UNITED STATES PATENT AND TRADEMARK OFFICE

| APPLICATION NO. | FILING DATE | FIRST NAMED INVENTOR | ATTORNEY DOCKET NO. | CONFIRMATION NO. |
|-----------------|-------------|----------------------|---------------------|------------------|
| 09/600,832      | 07/21/2000  | ANDREAS GIEFER       | 67526               | 2069             |

# Office Action Summary

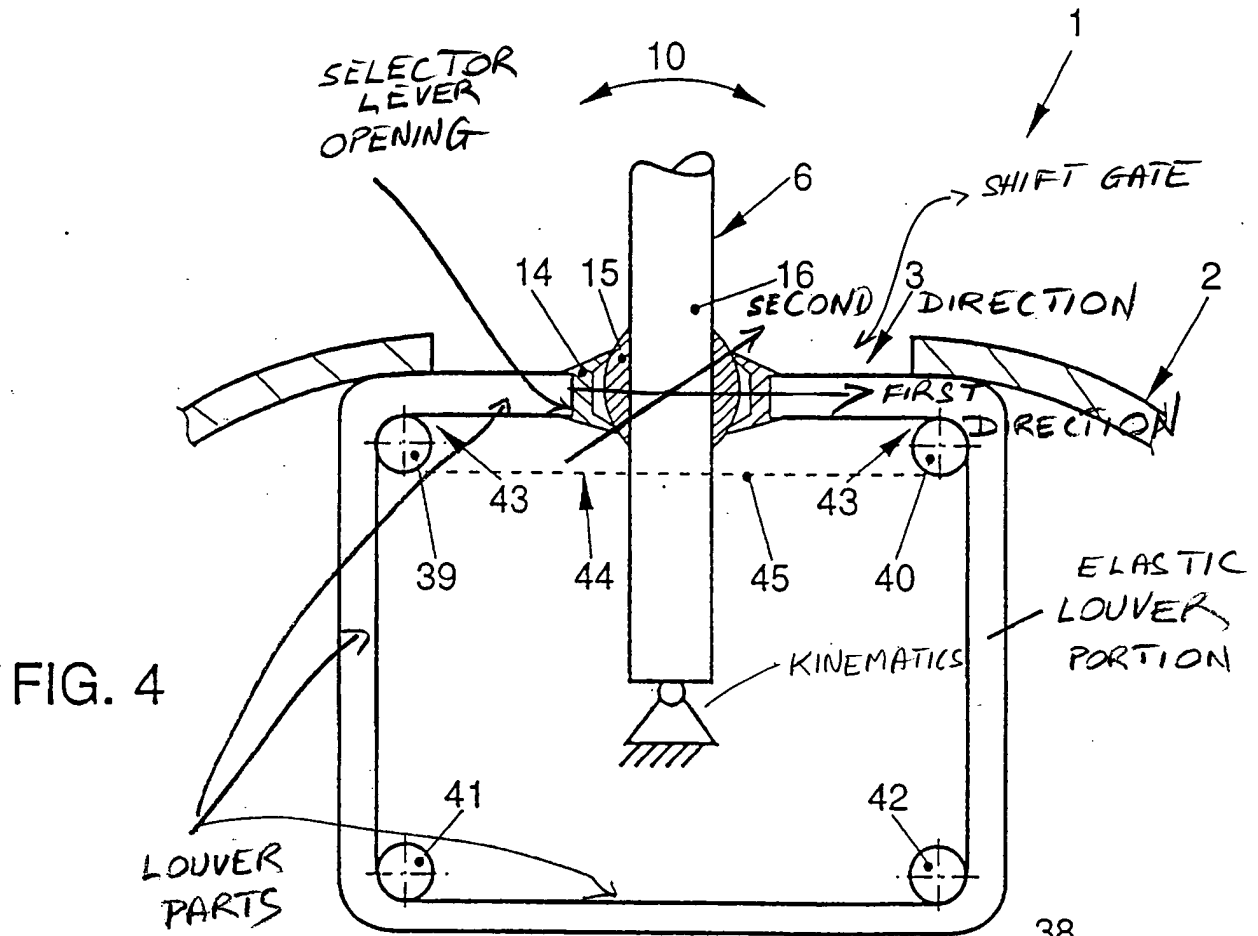
transmitting the selection movements to a transmission and at least one shift gate (at 3 in Fig. 4, see Exhibit attached), the slot cover comprising:

a movable louver 3 which covers the at least one shift gate, said louver 3 having at least one opening (see Exhibit attached) for the passage of the selector lever 6, 16, said louver 3 being an endless band forming a closed loop (Fig. 4);

Regarding claim 24, said deflecting element 39-42 is arranged within said louver closed loop 3 (Fig. 4).

Regarding claim 27, said louver 3 comprises an elastic louver portion (see the vertical portion in the Exhibit) having elastic properties, at least in the circumferential direction of the closed loop, said elastic louver portion being provided over at least a part of a length of said louver.

Regarding claim 28, said louver 3 comprises a plurality of parts (i.e., horizontal and vertical parts in Fig. 4 of the Exhibit).

a louver 3 movably connected to said louver guide 14, 15, 38-46 in a first direction (which is the first sideway direction of the pivotal movement/displacement of the lever 6 in Fig. 4), said louver 3 including an endless band 3 forming a closed loop, said louver defining a selector lever opening (see Exhibit);

a cover plate 2, said louver guide 14, 15, 38-46 being movably connected to said cover plate 2 in a second direction (which is the second sideway direction of the pivotal movement/displacement of the lever 6 in Fig. 4 as seen in Exhibit), said second direction being substantially perpendicular to said first direction.

Regarding claim 37, said first and second directions are in a plane substantially parallel to a plane of said cover plate 2 (see Exhibit).

FIG. 6

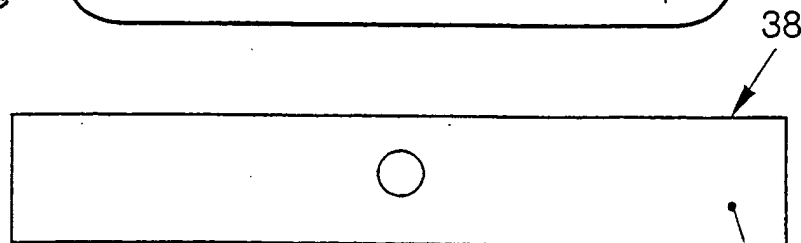
Regarding claim 29, said louver guide 14, 15, 38-46 includes a support structure 44 with slide rails 45 (Fig. 6) arranged laterally and engaged by said louver 3 for guiding said louver 3.
